1. Discussion and Possible Action on Recommendation for Construction Plans for Danamere Farms – Plat 8

RE: **Danamere Farms Plat 8 – Construction Plan Review**
Carlisle, Iowa
FOX Ref No: 8666-03C.258

FOX Engineering has completed the second review for of the Danamere Farms Plat 8 Construction Plans, dated June 11, 2020 and offer the following comments:

DANAMERE FARMS PLAT 8 CONSTRUCTION DRAWINGS

PAVING PLAN AND PROFILE

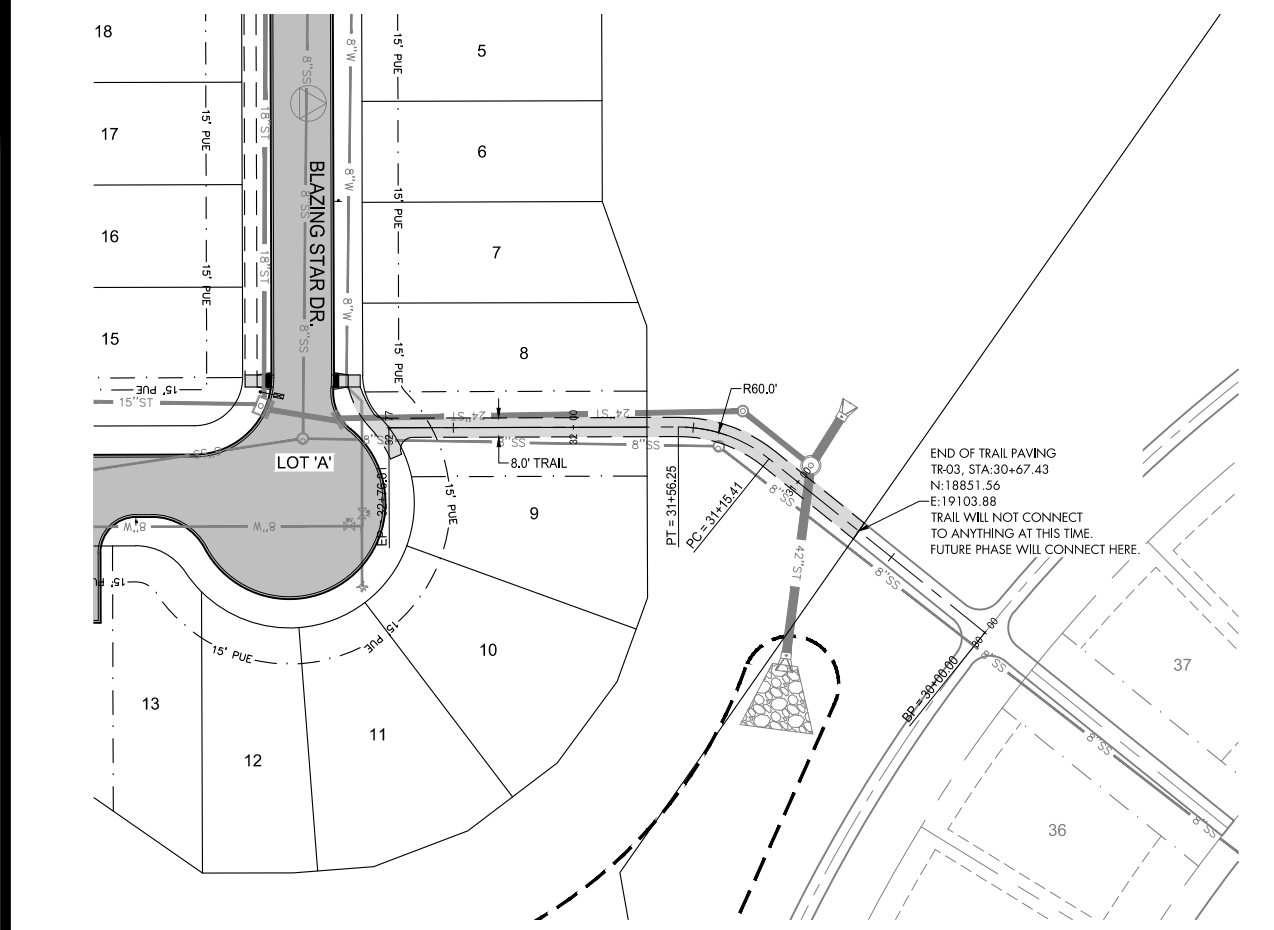
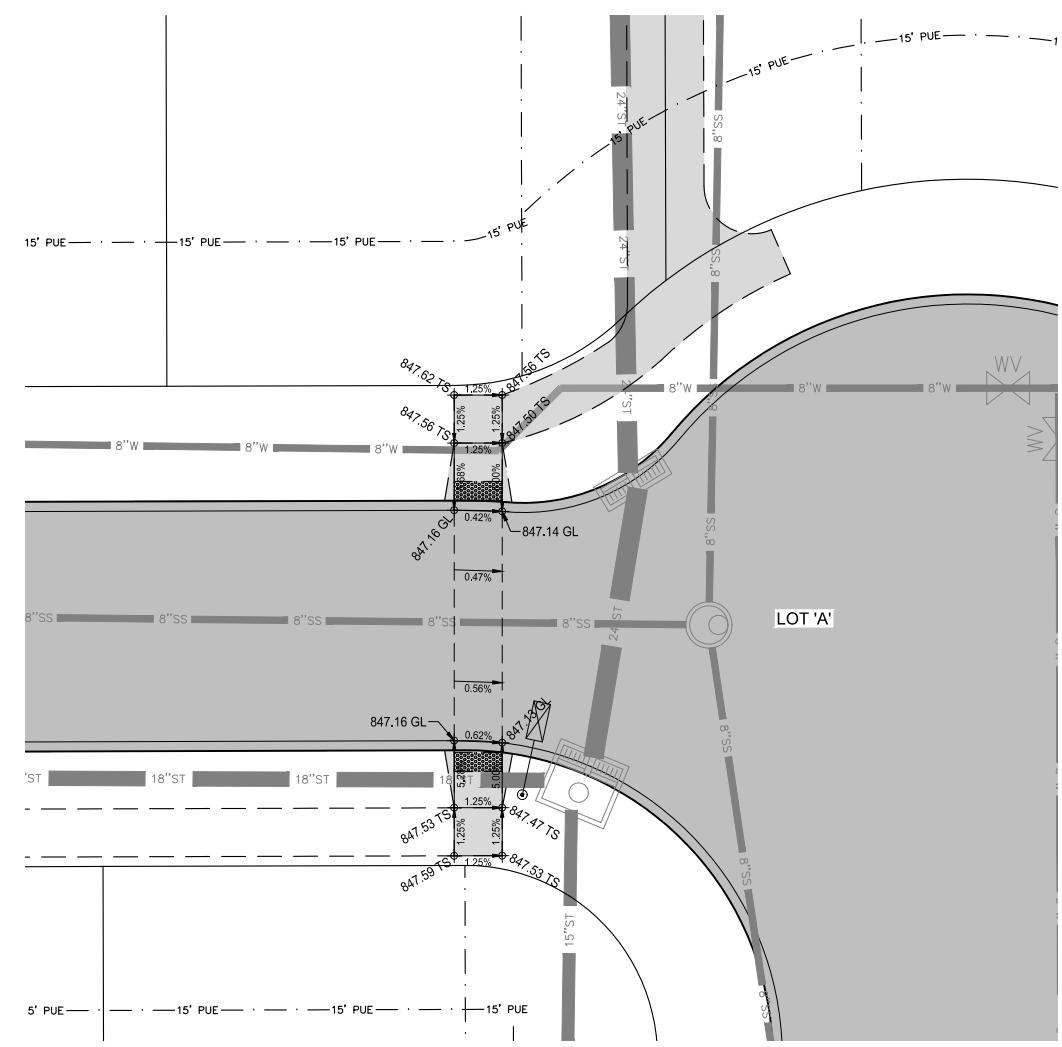
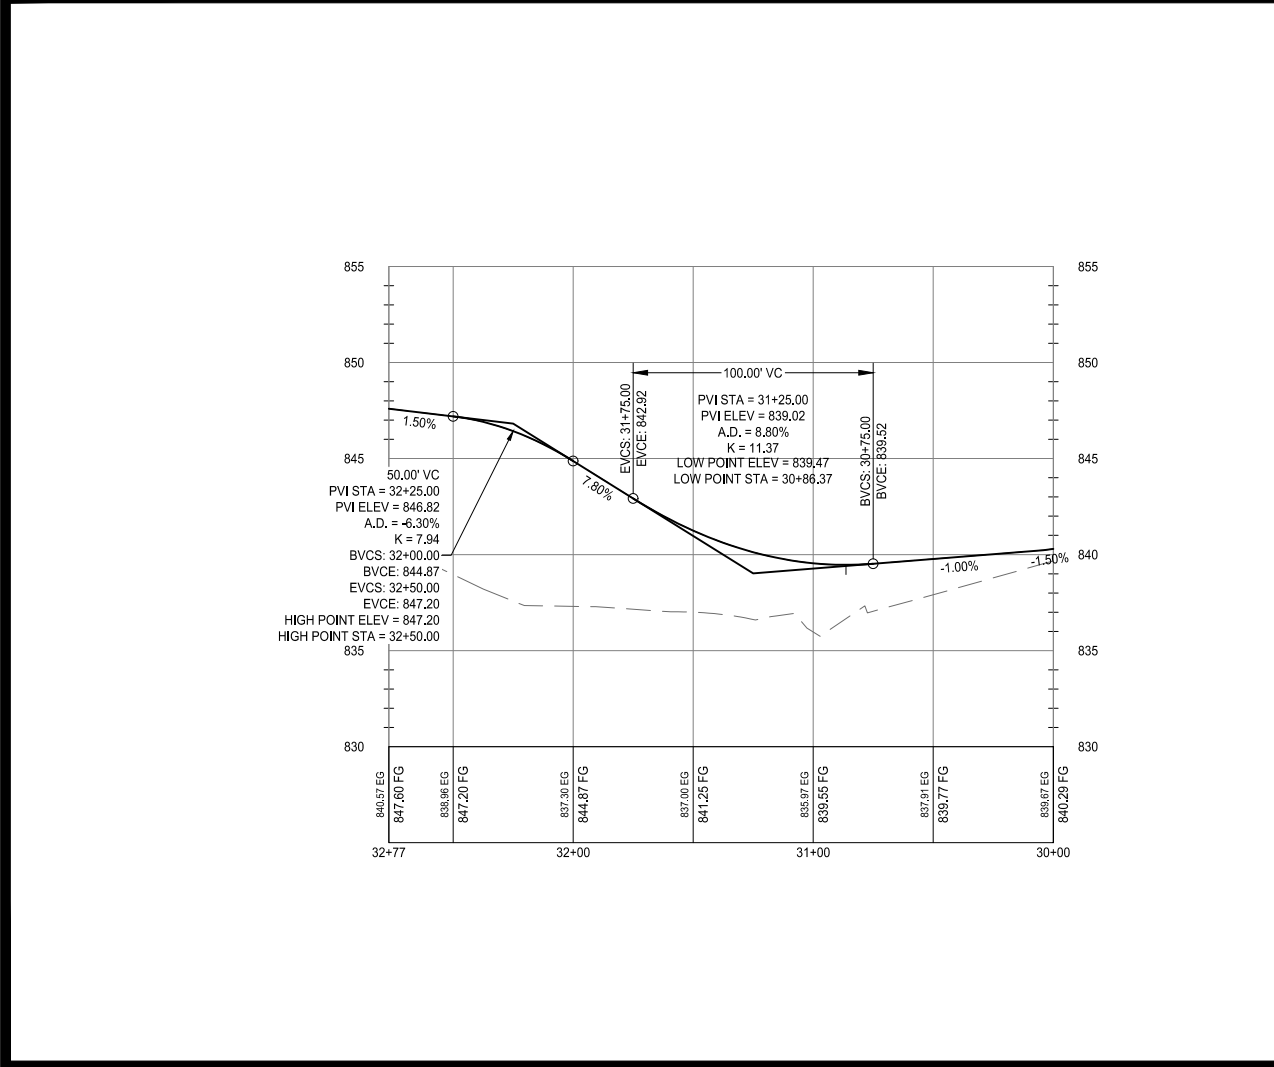
Sheet 11 – Paving Plan & Profile

10. Please include street sign on stop sign at intersection of Scotch Ridge and Blazing Star.

**TRAIL PAVING
PLAN AND PROFILE
ADA RAMP DETAIL**

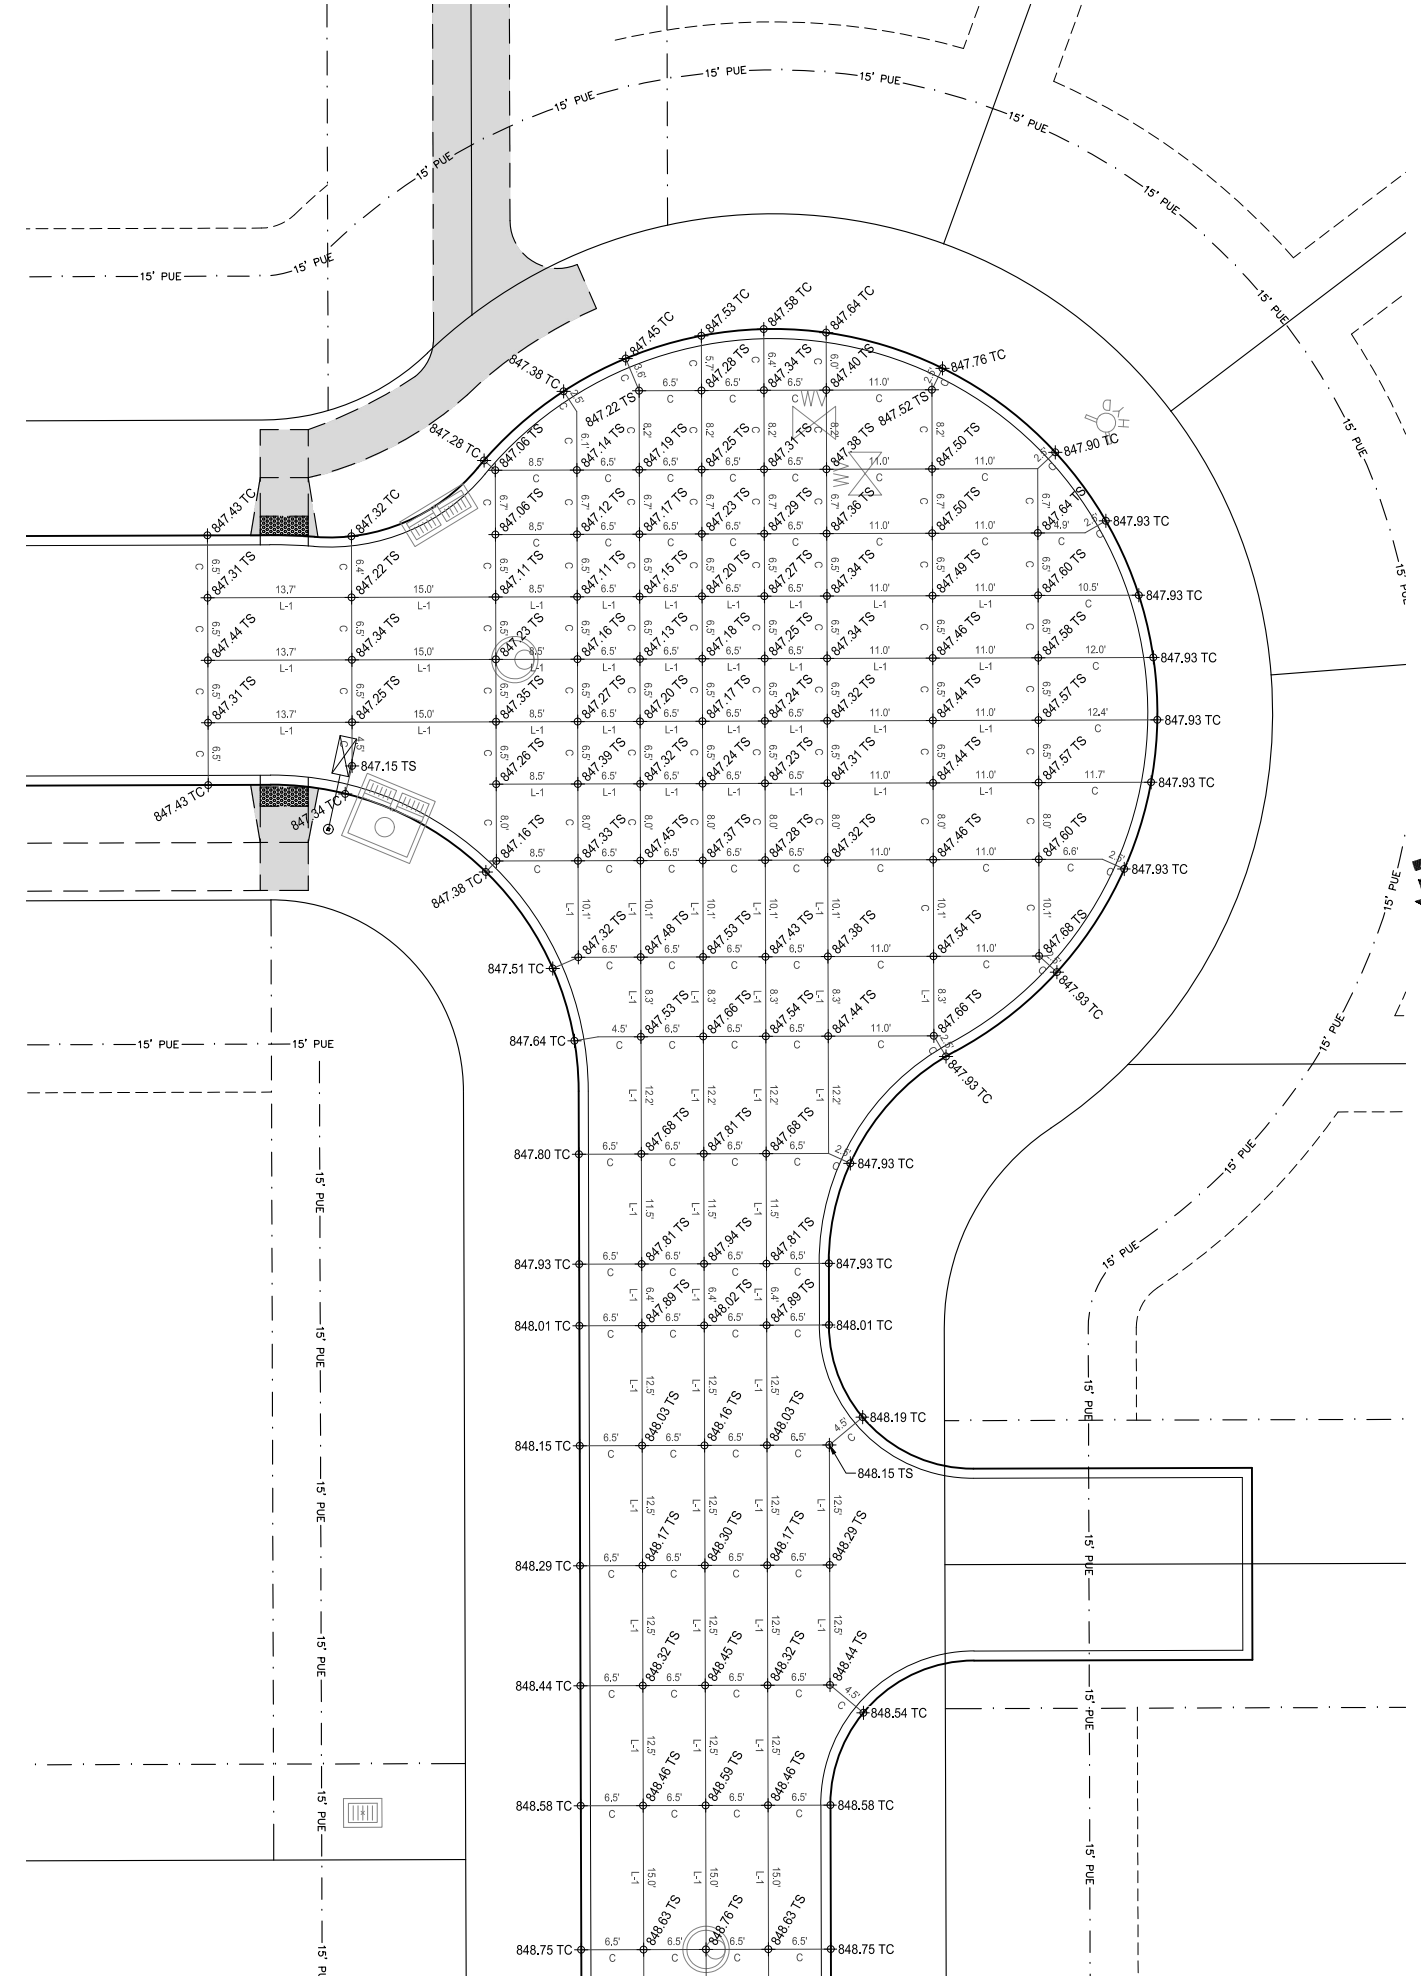
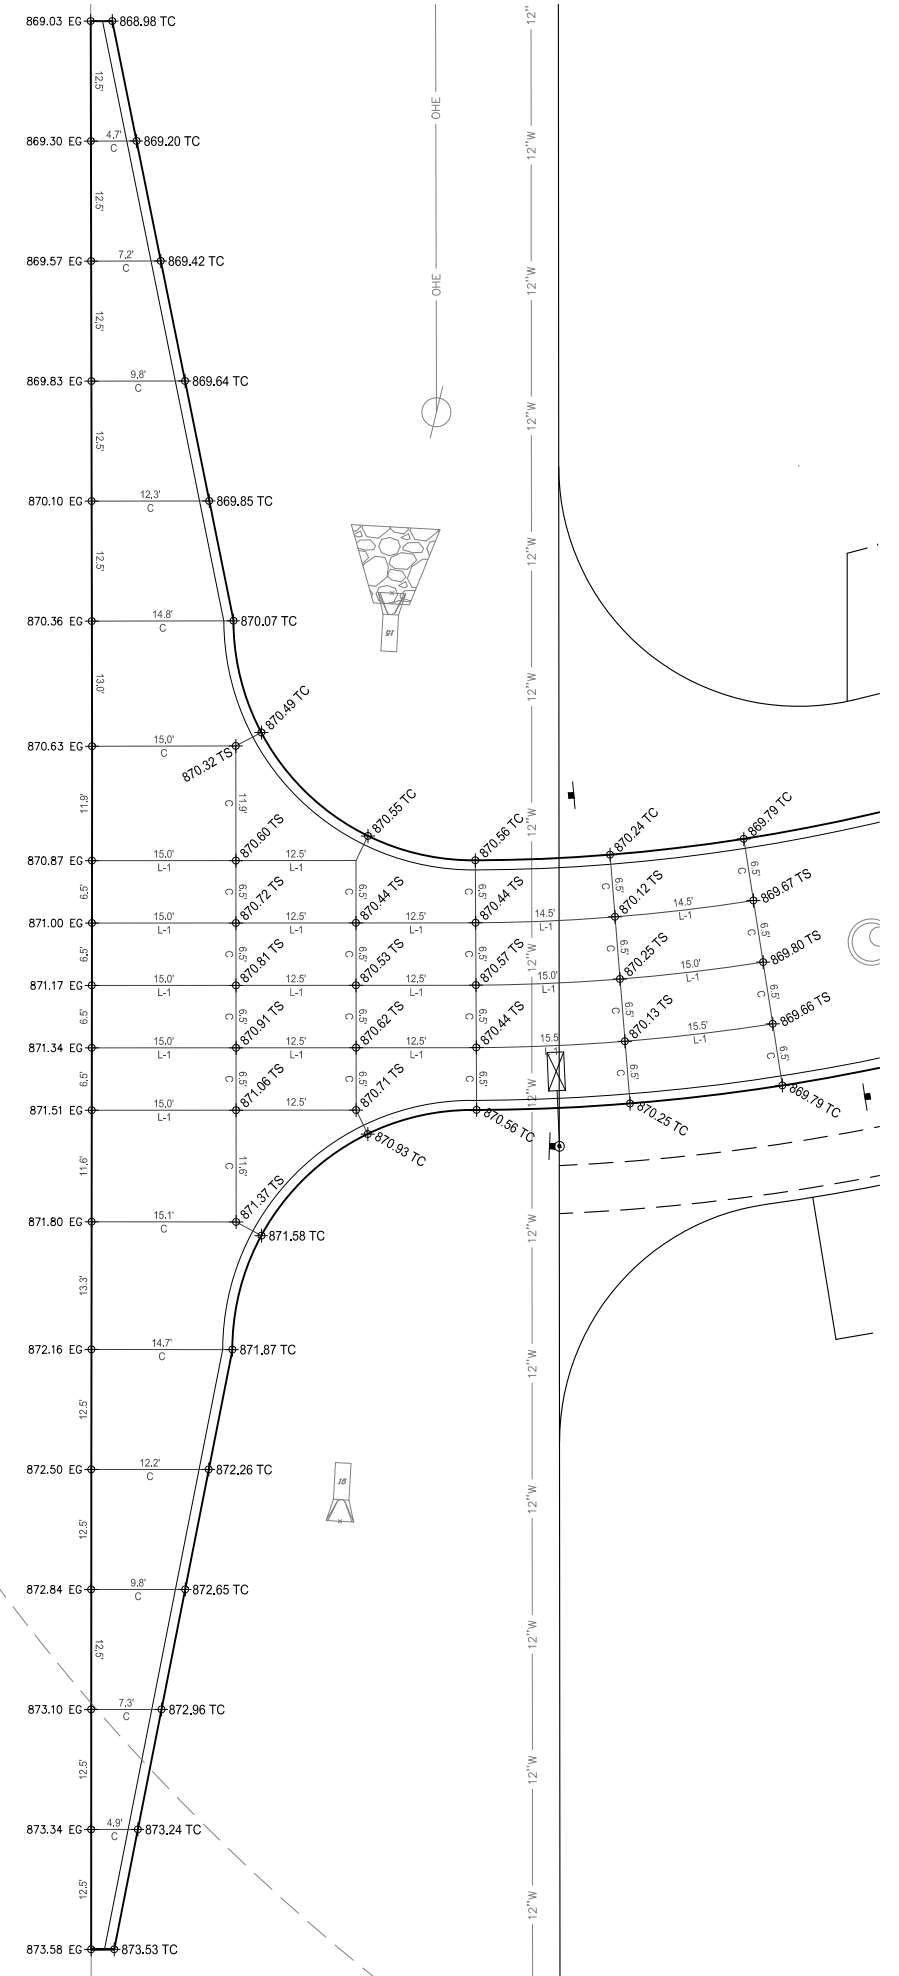
4. FOX believes the proposed trail should be treated as a Type 2 Shared use path since the trail will serve as the only pedestrian connection to other parts of Danamere and/or Carlisle (sidewalk/trail along Scotch Ridge was eliminated from this plan). As such, please revise the trail profile such that the maximum longitudinal slope along the trail is 5%.
